ADDENDUM NO. 1 TO PROJECT NO. 47010

ELECTRICAL WORK REPLACE EXISTING FIRE ALARM SYSTEM NEW YORK STATE CAPITOL STATE STREET ALBANY, NY

November 26, 2025

DRAWING NUMBER:
FAR-105

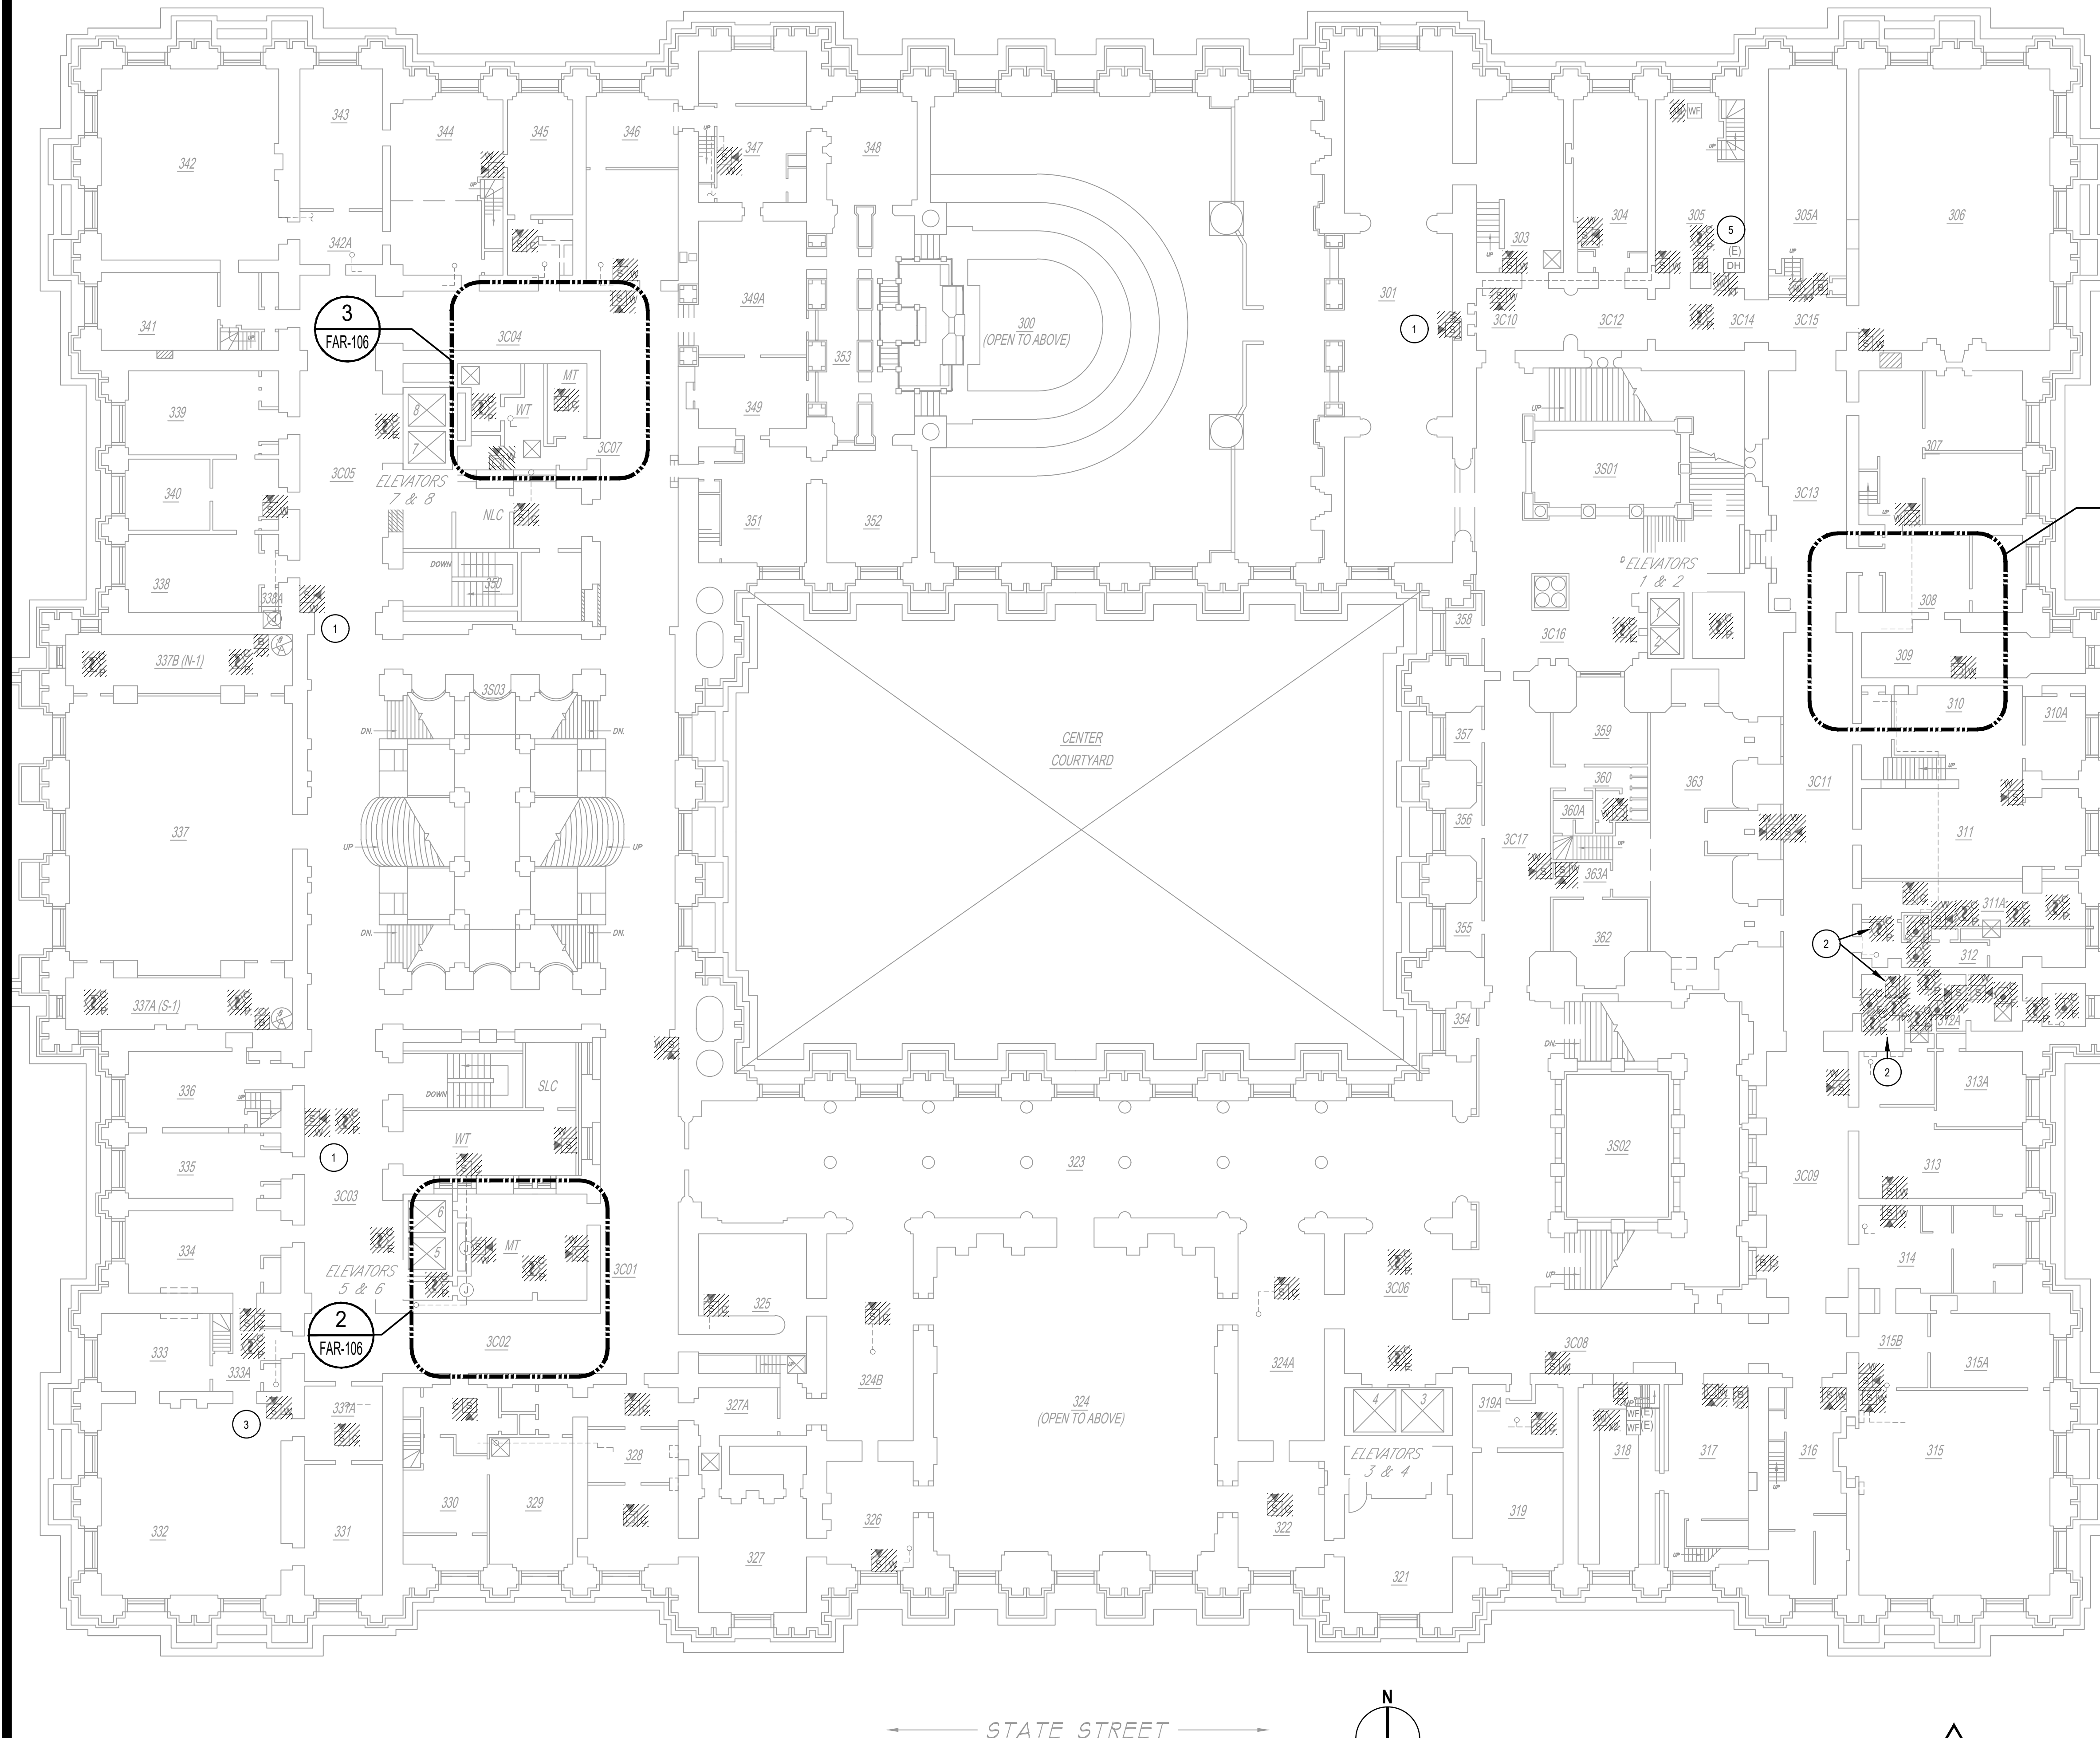
2
SCALING NOTE:
BUILDING BACKGROUND
SCALE HAS BEEN
UPDATED.
